World Forum for Harmonization of Vehicle Regulations

Proposal for Supplement 1 to the 03 series of amendments to UN Regulation No. 67 (LPG vehicles)

Submitted by the Working Party on General Safety Provisions *

"Figure 6
Connecting area of the J15 filling unit

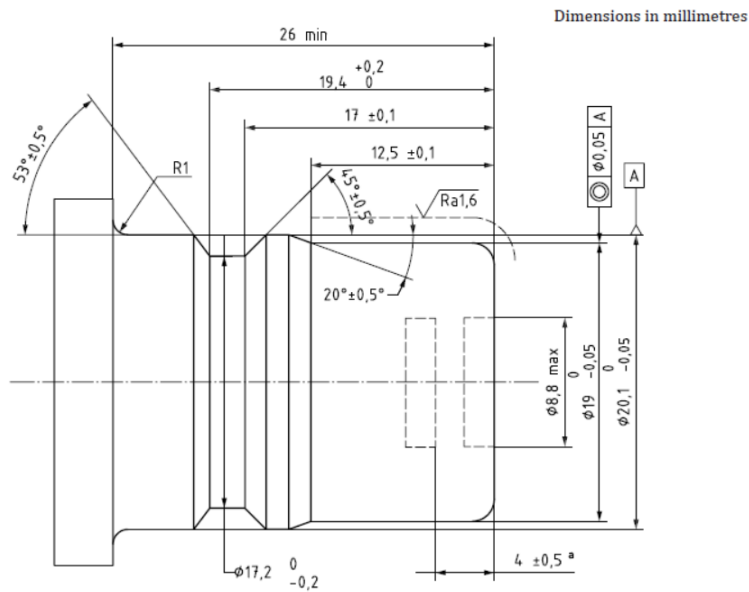
After Figure 5, insert a new Figure 6:

Key
 A reference for geometrical tolerances
 Ra surface roughness
 R1 radius
 a Stroke.
